1200 STEWART STREET

ALLEY VACATION DESIGN COMMISSION MEETING #3

> **April 1, 2010** DPD PROJECT 3007548

DENNY AND MINOR – PREVIOUS DESIGN

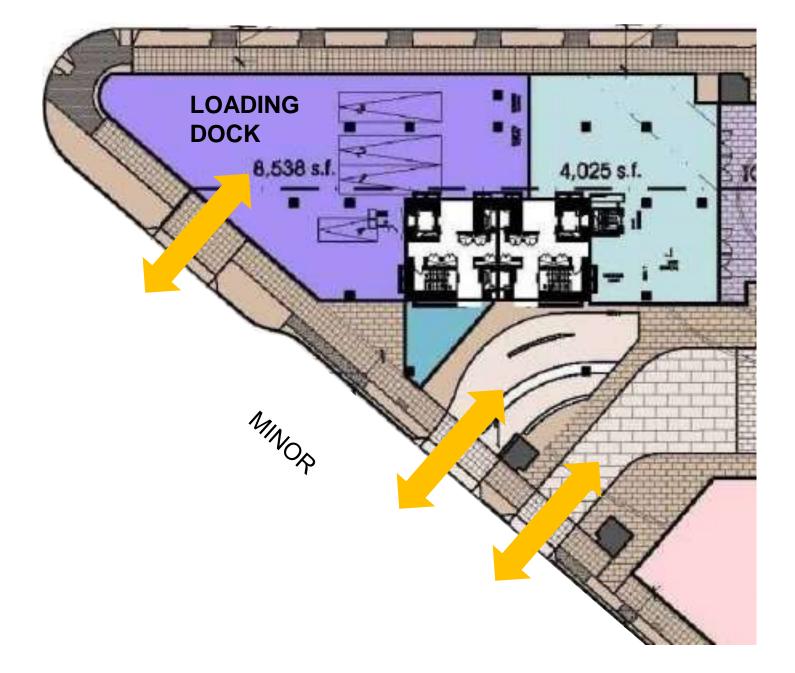
- "Concerned about the lack of crosswalk markings in nonsignalized intersections"
- "There is concern about the design of the Denny and Minor corner"
- "Provide maintenance agreement for offsite improvements"

- Loading dock moved below grade
- Full retail on important corner
- Eliminated one curb cut
